Title: Independent Review of Siesmic Performance Assessments for the Plutonium Facility PF-4

**Independent Review of Seismic Performance Assessments for the
Plutonium Facility PF-4**

Rev 1
October 2, 2015

Figure 1.3. Chase floor slab connections (from Fluor 1977)

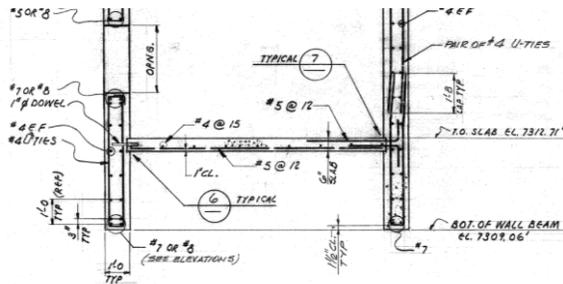
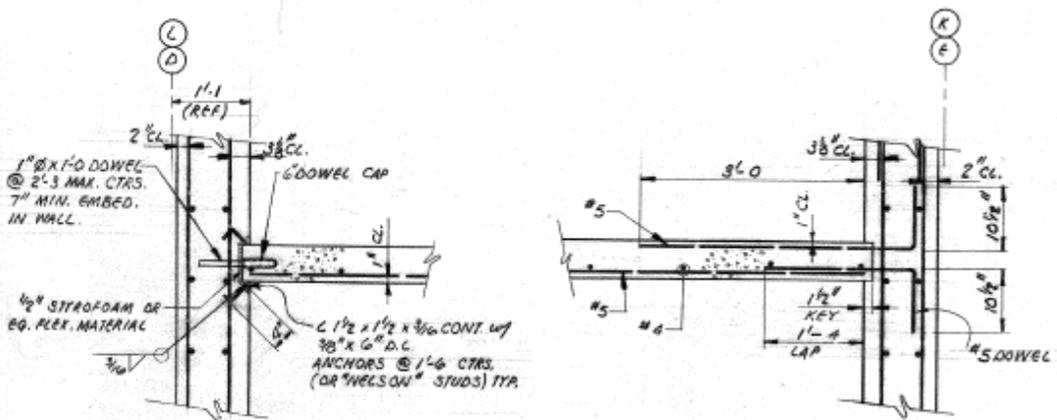
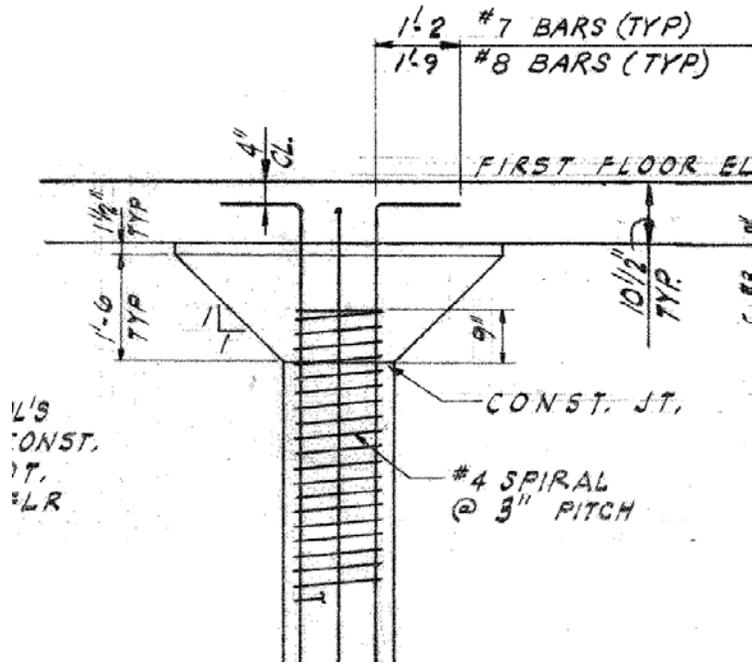
SGH developed a much more detailed model of the framing in the vicinity of the service chases. They estimated that a free-to-slip feature associated with the chase floor slab (see Figure 1.3d, left hand panel) is likely to lock-up under earthquake shaking. Accordingly, the SGH model provides significant rotational resistance to the interior girders at Lines E and K.

shoring beneath the roof girders and slabs, both of which are unknown, and the integrity of the slip detail associated with the service chase floor slab, which is also unknown. The state of the sliding joint and its compressible material may also have been affected by concrete shrinkage, but that was not monitored and its effect has not yet been investigated.

Figure 3.1. PF-4 Type V column capital and finite element model

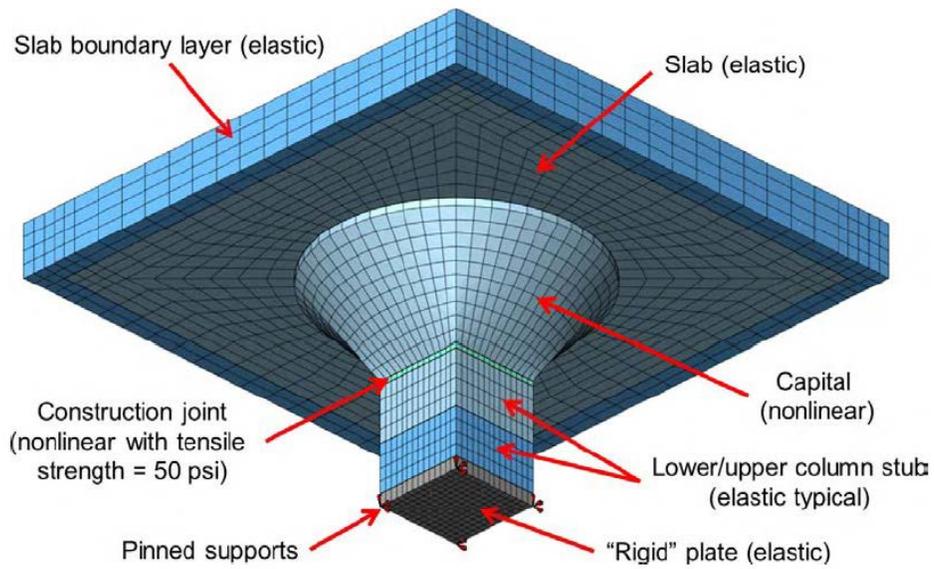
Section 4.4 of this report describes the SGH assessment of the column capitals that support the laboratory floor slab. A sample capital is shown in Figure 3.1a. The integrity of the column capitals is critical to the support of the laboratory floor under gravity loadings; the loss of the capitals, for whatever reason, will sufficiently reduce the punching shear perimeter of the slab to trigger a local collapse. The column capitals are not reinforced, as would be routine practice today. Their integrity as a continuum of concrete cannot be guaranteed in the event of design basis shaking because there are no test data available from which to either judge likely performance in the event of design basis shaking or validate numerical tools with sufficient confidence to accurately predict performance.

We recommend that representative slab-capital-column systems be physically tested to simulate gravity and earthquake effects. As a minimum, a sufficient number of tests should be performed, at or near full scale, to characterize the performance of the Type V slab-capital-column assemblies in PF-4. The testing program should provide the raw data and metadata needed to

Figure 4.2. MMPA, RSA, and modal response history shear at south end of girder EH (SGH 2014c)

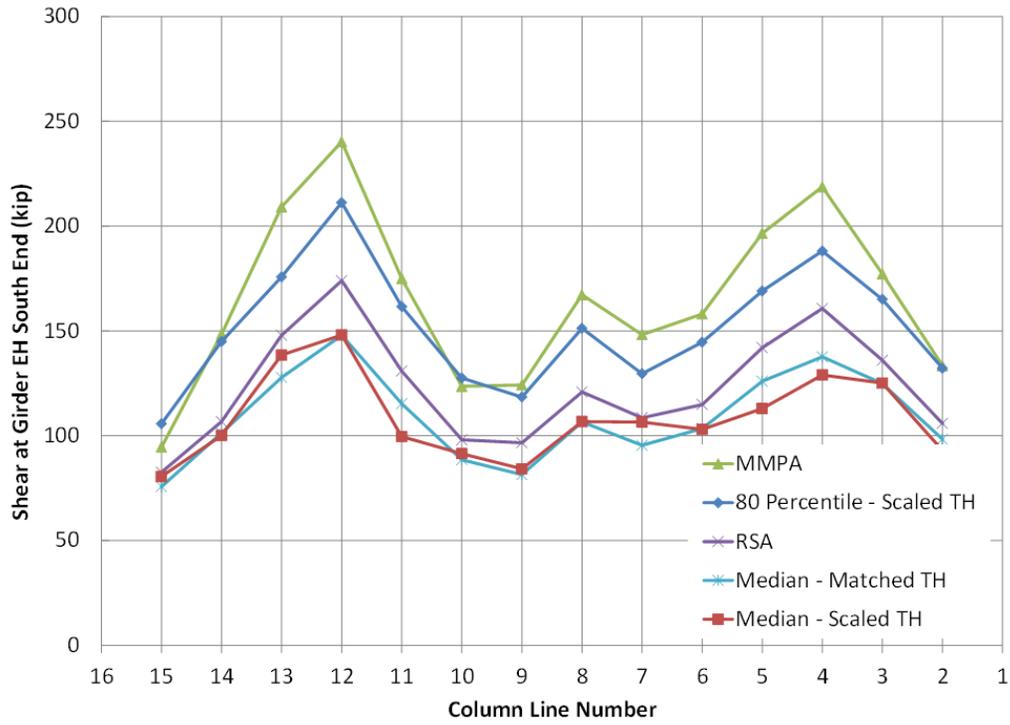
Figure 4.2 presents the shears at the south ends (E) of interior girder EH calculated using the MMPA, response-spectrum analysis (RSA), and response-history analysis (denoted TH in the legend to the figure). Results are presented for Lines 2 through 15, noting that Lines 1 and 16 are walls (no girders). In these analyses, a) the MMPA considers nonlinear response but the roof girders are modeled as equivalent linear elements, b) the response-spectrum analysis is (by definition) linear, and c) the response-history analyses are linear. The MMPA shears are generally greater than the 80% NEP shears from the 11 response-history analyses using the scaled ground motions, noting that the dispersion in the scaled motions is too high, as noted above. This figure indicates that the MMPA method has a significant conservative bias, namely, it overestimates demand. However, we were not able to determine why the MMPA method calculates greater girder shears than those calculated using the spectrally-matched ground motions (Median-Matched TH in the figure) when the same building model and damping are

Figure 4.3. AFUP ($\times 10^{-4}$) of roof girder failure due to shear (adapted from Mertz et al. 2015b)

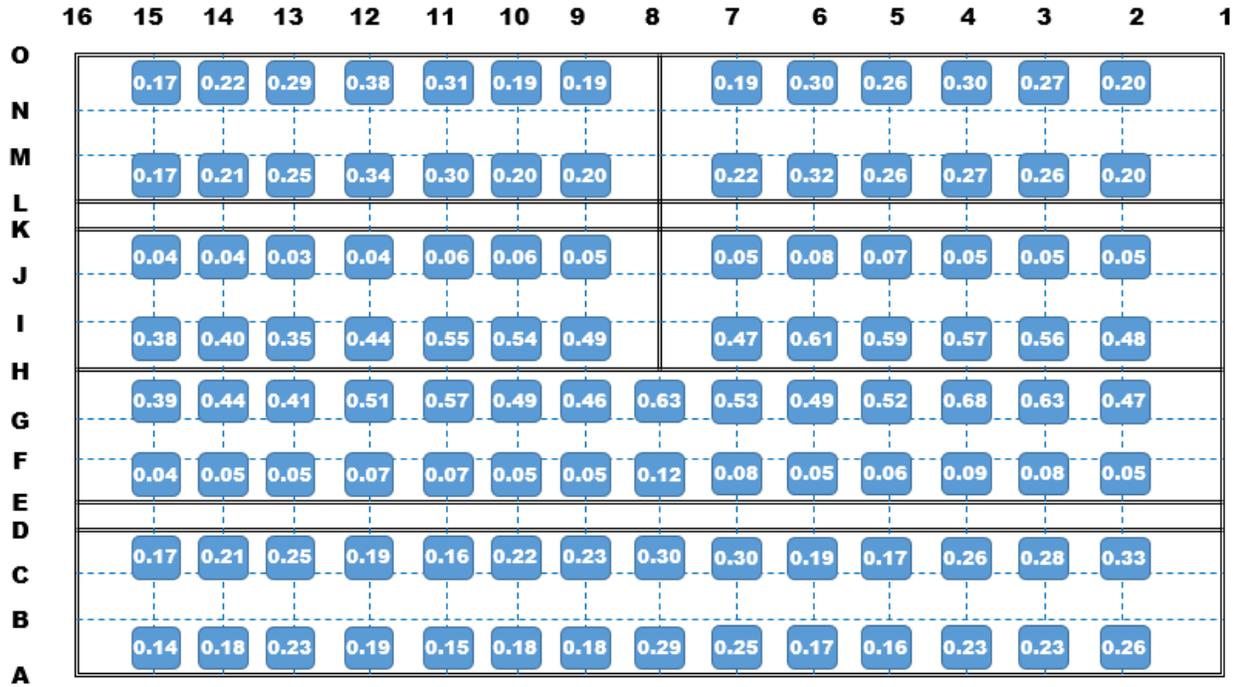
We find the AFUP results reported in Figure 4.3 along Line H to be reasonable and consistent with the $D_{80\%}/C_{ACI}$ reported by CJC in Table 4.1 and our adjusted values that are reported in Table 4.5. The AFUP on Line H range from a high of 0.68×10^{-4} at Line H of girder EH on Line 4 to a low of 0.35×10^{-4} at Line H of girder HK on Line 13. However, we also recognize that considerable variability exists between the $D_{80\%}/C_{ACI}$ computed by CJC and our adjusted SGH $D_{80\%}/C_{ACI}$ on Line H, as is shown in Table 4.5. Therefore, we recommend that any increase in shear capacity to the girders be applied on both sides of Line H from Lines 2 through 15 and that the decision whether to upgrade be based on the highest AFUP of 0.68×10^{-4} .

The very low values of the AFUP reported at Line E of girder EH and Line K of girder HK seem to be consistent with the small values of $D_{80\%}/C_{ACI}$ reported by CJC in Table 4.1. However, in Table 4.5 we increased these ratios by a factor of 1.35 to address the unknown rotational restraint provided by the service chases. This increase will result in a substantial increase in the AFUP at Lines E and K above those values shown in Figure 4.3. However, even after this increase, we expect the AFUP at Lines E and K to be low.

We do not understand the low values of AFUP values reported in Figure 4.3 for the exterior girders AD and LO. These low values are not consistent with the values of $D_{80\%}/C_{ACI}$ reported by CJC in Table 4.2. Based on the reported values of $D_{80\%}/C_{ACI}$, we would have expected the AFUP for the exterior girders AD and LO Girders to have been between 0.3×10^{-4} and 0.5×10^{-4} on Lines 2 through 7 and 9 through 15. Regardless, these values are low and do not warrant further review unless the studies identified in Section 5 determine that the service chases provide significant rotational restraint to the exterior girders, drawing a significant fraction of the total shearing force away from the perimeter support of these girders.

The other roof girder of immediate concern is the exterior girder AD on Line 8. Notwithstanding the low AFUP computed by CJC (see Figure 4.3), but based on the high D/C computed by CJC (see Table 4.5), we recommend increasing its shear capacity at both ends. The low AFUP computed by CJC was based on potentially unconservative assumptions, namely, the contribution to the shear resistance from flange (slab) and drag strut concrete. We recommend the shear capacity of both ends of girder AD on Line 8 be increased by a minimum of 60 kips, which will reduce the CJC-computed D/C ratio from 0.95 to 0.80: see Table 4.5 under the sub-heading “Recommended Retrofit.”

Figure 4.4. Cross section through roof girder at Line 8 drag strut used to calculate shear capacity (courtesy of CJC)

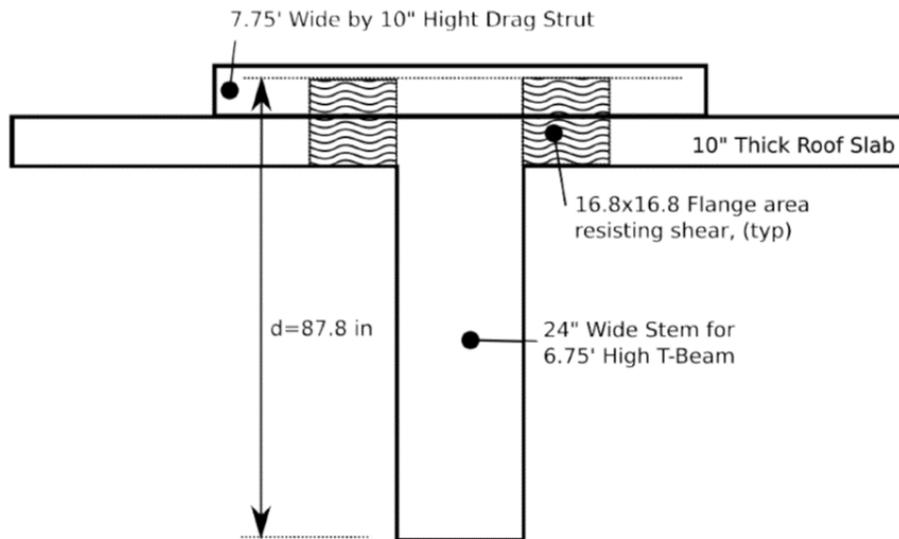
From a behavior perspective, the shear failure of a T-beam occurs on an inclined crack plane. The inclined crack plane must cross the T-beam flange and on Gridline 8, the crack plane must also cross the drag strut. Thus, some portion of the roof flange and the drag strut will resist shear in addition to the T-beam web.

As discussed above, the D/C ratio reported in response to the SEP data request (Excel spreadsheet) neglected the contribution of the flanges and drag strut to shear capacity.

Figure 4.6. SGH model of girder to chase corridor connection (SGH 2014c)

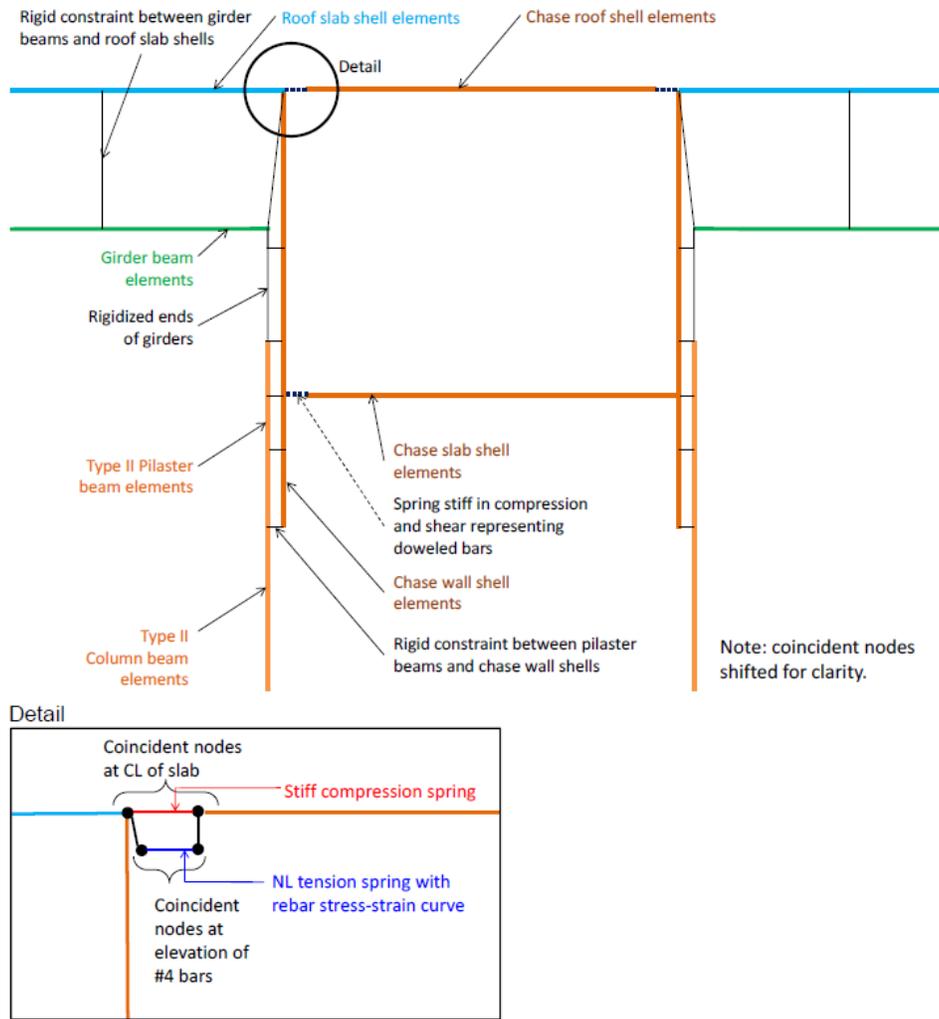
The SGH model explicitly addresses these condition details, as described in Figure 4.6. The chase roof slab is connected with compression and tension springs intended to model the stiff concrete bearing resistance in compression, and the compliance of the rebar in tension. The service chase floor slab appears to be free to slip in tension but is provided with a “stiff” compression spring, reflecting a perceived unreliability of the joint to slide freely or perhaps locking of the compression material after a finite movement. From this figure, it appears that the chase roof and/or slab shell elements indeed provide some measure of resistance to girder flexure by virtue of their elevations relative to the top and bottom of the rigid zone defined by the girder depth. That is, either the roof or floor slab of the chase corridor can introduce a kinematic rotational restraint under vertical loading; the degree of restraint depends on the stiffness of the springs used to model the joints and the restraint provided by the exterior girder spans.

The models adopted by SGH and CJC effectively bound the restraint provided to the EH girders, with the *actual* restraint along the chase/service tunnel being dependent on the as-built joint detail and on the timing / sequence of the shoring removal from beneath the roof girders and slabs, both of which are unknown. We have quantified this difference and adjusted the SGH and CJC demands accordingly; see Section 4.3.

Figure 5.1. Potential column capture by the service chase floor slab (from Fluor 1977)

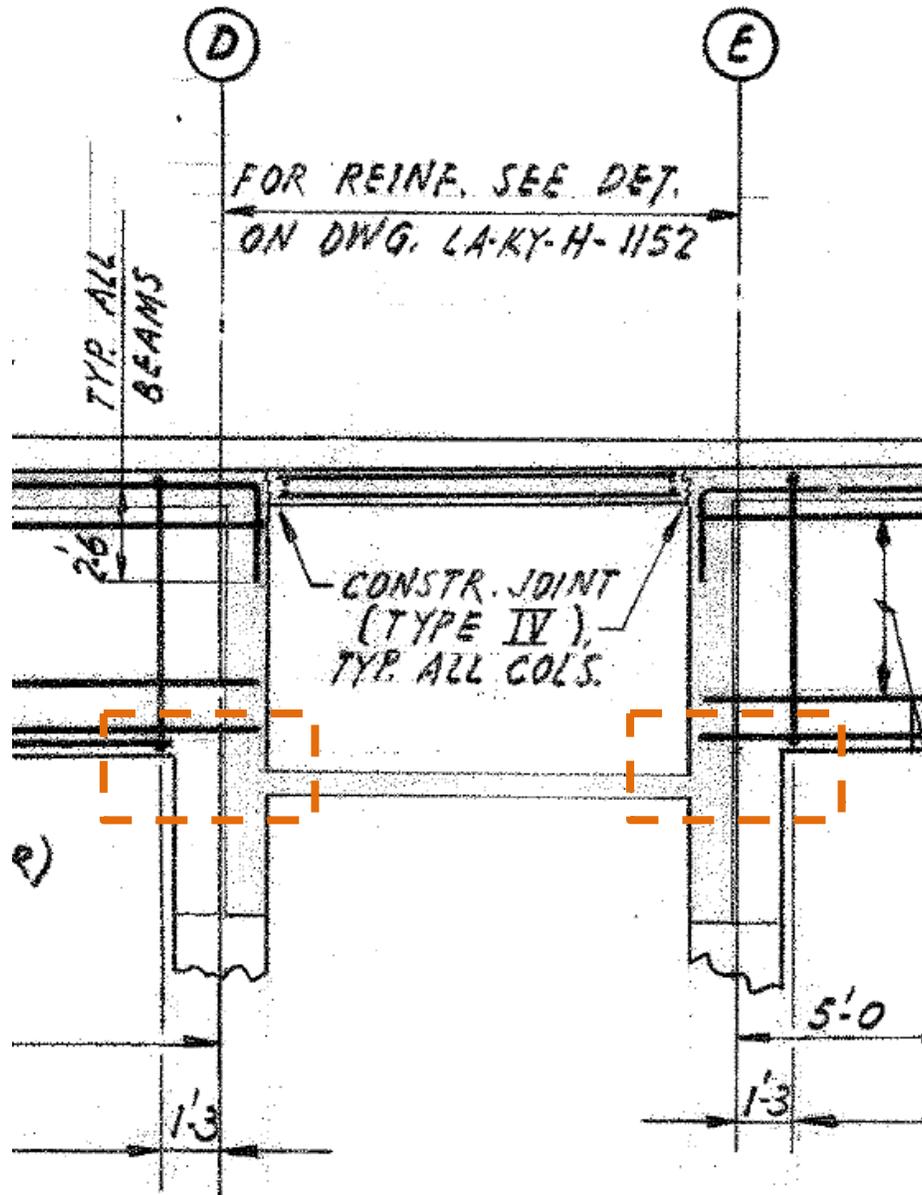
At Lines D and E, the negative moment (top) reinforcement in the roof beams are hooked down into the column below, and positive moment (bottom) reinforcement extends straight into the column: see Figure 1.3b. The roof slab over the service chase (Figure 1.3c) was cast after the adjacent roof beams and spans as a simply supported element between the walls of the service chase on Lines D and E. Starter bars from the adjacent roof slab are lapped with the positive moment (bottom) reinforcement in the chase roof slab. The typical section through the service chase (Figure 1.3d) identifies floor slab to service-chase wall connection details: a sliding connection on Lines D and L (detail 6) and a conventional connection on Lines E and K (detail 7). We believe that the designer's intent with the sliding connection was to prevent axial force transfer through the floor slab. We have no means by which to confirm that either the dowels or the flexible (compressive) material shown in the detail can serve the intended purpose, forty years after construction. If this detail does not function as intended, and the service chase floor slab restrains lateral movement of the column, the column will be captured and very high shear forces may be developed in the column during earthquake shaking. The dashed orange boxes in Figure 5.1 identify the regions of concern to the SEP.

The SEP recommends four studies be performed in regard to this detail: 1) an inspection of the tops of the columns, above the service chase floor slab and below the underside of the roof beams, on Lines D, E, K and L, to gage whether any of the columns have cracked in shear under gravity-induced loadings, 2) a physical inspection of the sliding joint detail (left panel of Figure 3d) at a number of locations along each service chase to determine the current condition of the flexible material, 3) an analysis of the potential for shear failure of the columns and the resultant vulnerability of PF-4, and 4) an analysis of the seismic vulnerability of the exterior roof girders if the examination of 3) shows that the service chase construction provides fixity to the girders. These studies are considered *required*.
